PERMIT

SEWAGE DISPOSAL SYSTEM

MARYLAND STATE DEPARTMENT OF HEALTH

SUBDIVISION ROAD 6705 Mink Hollow Road Parcel 9

PERMIT CARD

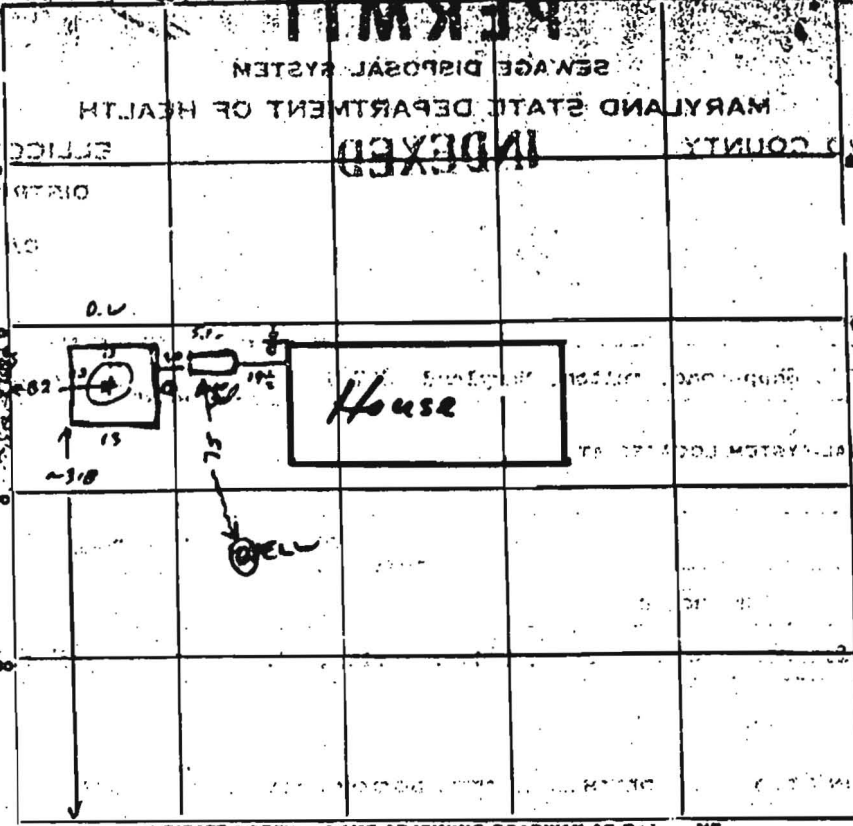
1) inlet @ 3', max depth 13'

2) D.W. too close to sideline by 120 ft if sideline is @ Barker

3) re-seal below pipe where enters 55' from house R.M.

fill 13' hole dug - soil ok.

(2) S.T. Level

(3) lower line sealed to 5.7
